# UNITED STATES PATENT AND TRADEMARK OFFICE

APPLICATION NO.	FILING DATE	FIRST NAMED INVENTOR	ATTORNEY DOCKET NO.	CONFIRMATION NO.
10/596,039	03/27/2008	Charles Chapus	171.006	1965
38245	7590	11/10/2011		
JEROME D. JACKSON (JACKSON PATENT LAW OFFICE)			EXAMINER	
211 N. UNION STREET, SUITE 100			DEERY, ERIN LEAH	
ALEXANDRIA, VA 22314				
			ART UNIT	PAPER NUMBER
			3751	
			NOTIFICATION DATE	DELIVERY MODE
			11/10/2011	ELECTRONIC

<b>Office Action Summary</b>	<b>Application No.</b> 10/596,039	<b>Applicant(s)</b> CHAPUS, CHARLES	
	<b>Examiner</b> ERIN DEERY	<b>Art Unit</b> 3751

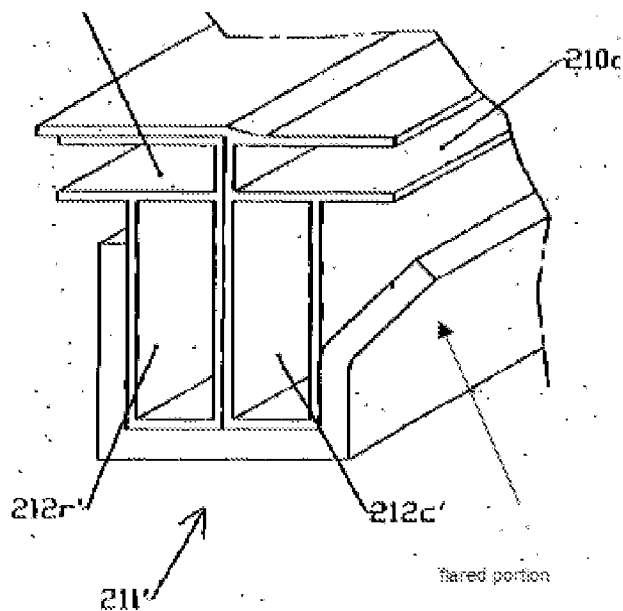
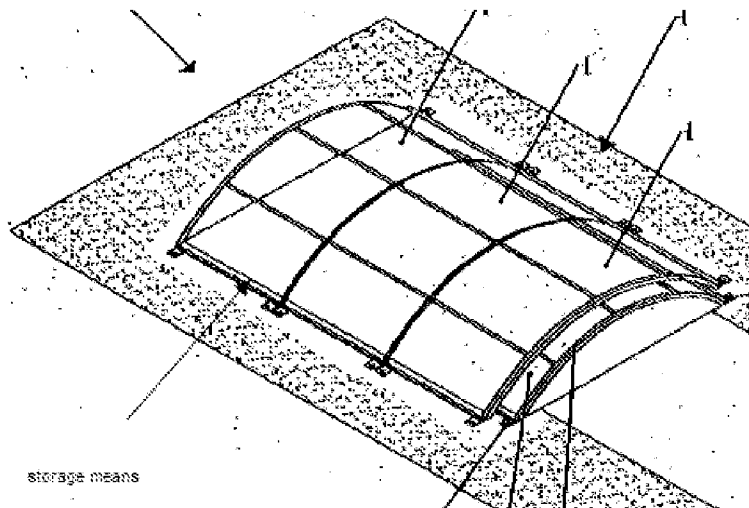
24. Regarding claims 11 - 14, Chapus shows a connection means, having arches with wings (210) which extend over the panels and permit sealed covering of the roof components (see fig. 8a). The connection means also allows the roof components to be articulated relative to the support edge of the pool (fig. 2), as the connection means are dissociable from one another in a vertical direction. There is a U-shaped profile (211) which conforms to the shape of the rectangular lower profiles of the arches and is

'fastened,' such that the rectangular profiles are housed and inserted into the U-shaped profile (see fig. 8a and 8b). There is finally a flared edge (see annotate figure) of the U-shaped profile, which allows 'play' of the arch when the roof component is in a juxtaposed position.
